**RE: National Construction Code (NCC) 2022 Amendment 2 Volume
One Section J Part J4 Statement of Compliance**

JOB NO.: 240516

SUBJECT PREMISE: Opal Bayview Gardens | Annam Road Bayview, NSW 2104

Attachment B – Building Fabric Requirements Markups

A103 LEVEL 1
SCALE: 1:200
0 5.0M 10.0M

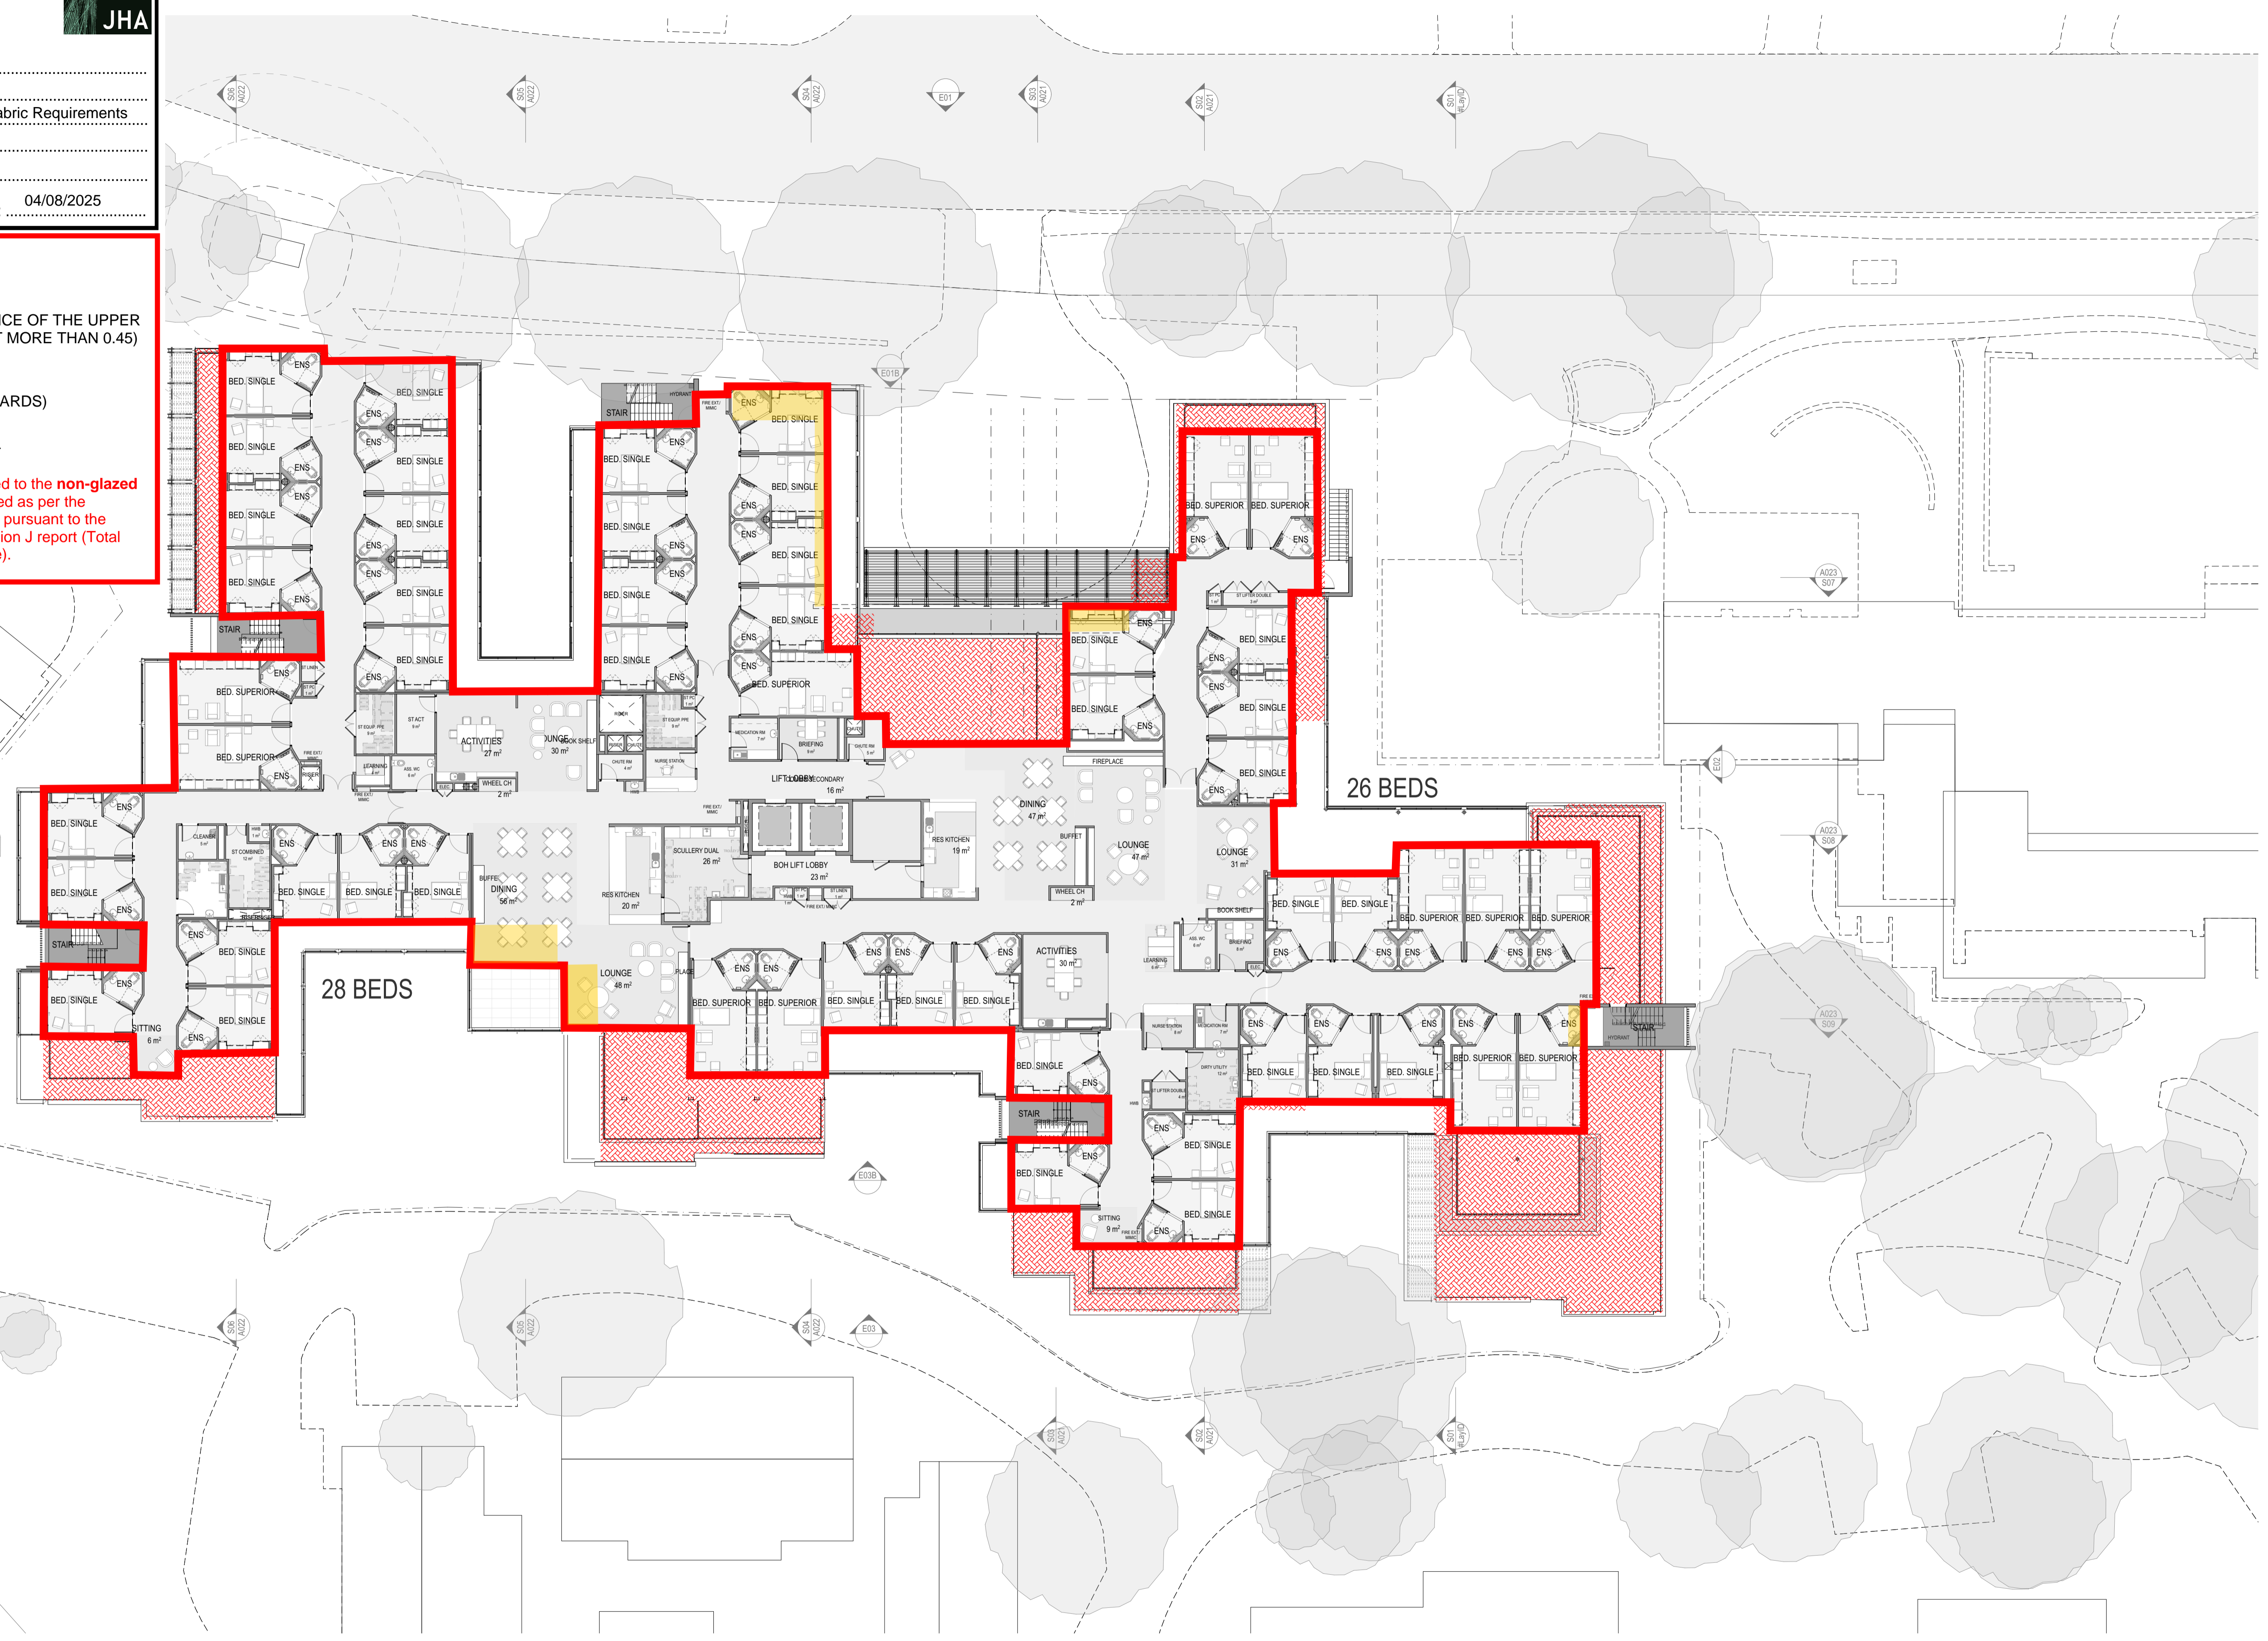
KEY
ROOF/EXPOSED CEILING - R3.7
(DOWNWARDS, SOLAR ABSORPTANCE OF THE UPPER SURFACE OF A ROOF MUST BE NOT MORE THAN 0.45)
ENVELOPE FLOORS - R2.0 (DOWNWARDS)
EXTERNAL ENVELOPE WALLS - R1.4
Note: The above construction are only to be applied to the non-glazed portions of the envelope; glazing must be installed as per the architectural layouts with its thermal performances pursuant to the respective glazing specifications stated in the Section J report (Total Systems U-Value, and Total Systems SHGC value).

A104 LEVEL 2
SCALE: 1:200
0 5.0M 10.0M

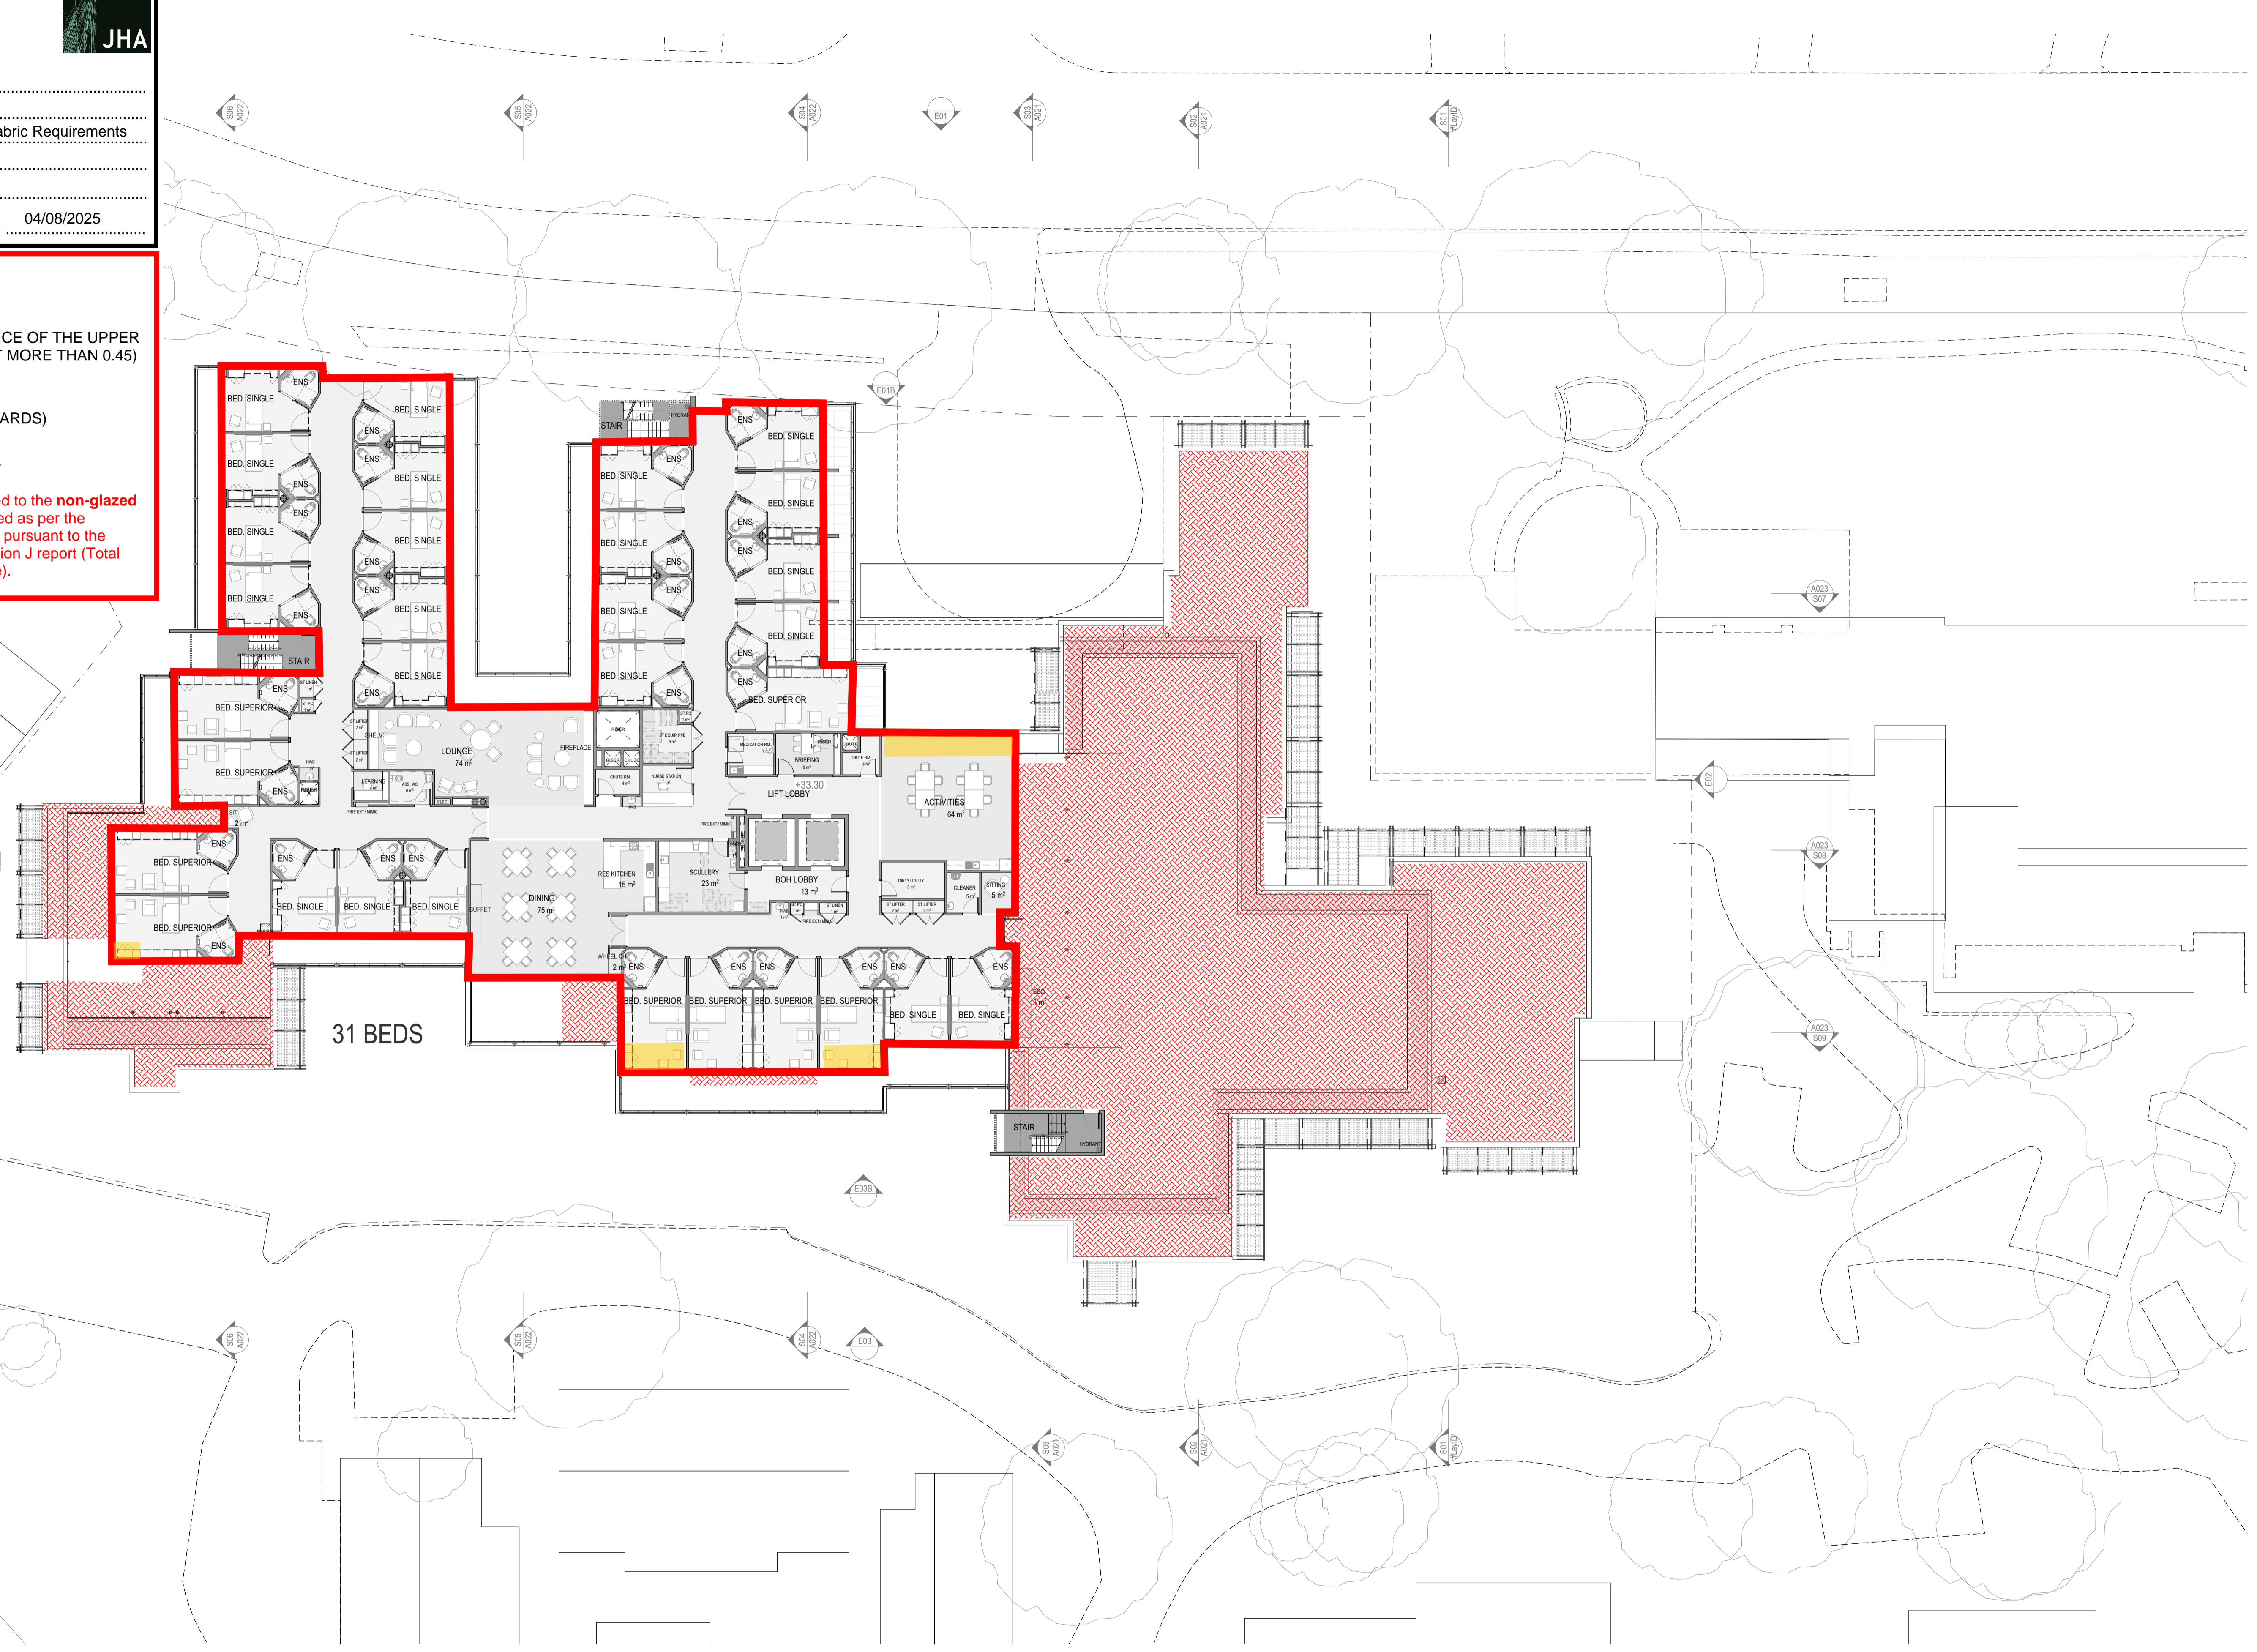
KEY
ROOF/EXPOSED CEILING - R3.7
(DOWNWARDS, SOLAR ABSORPTANCE OF THE UPPER SURFACE OF A ROOF MUST BE NOT MORE THAN 0.45)
ENVELOPE FLOORS - R2.0 (DOWNWARDS)
EXTERNAL ENVELOPE WALLS - R1.4
Note: The above construction are only to be applied to the non-glazed portions of the envelope; glazing must be installed as per the architectural layouts with its thermal performances pursuant to the respective glazing specifications stated in the Section J report (Total Systems U-Value, and Total Systems SHGC value).
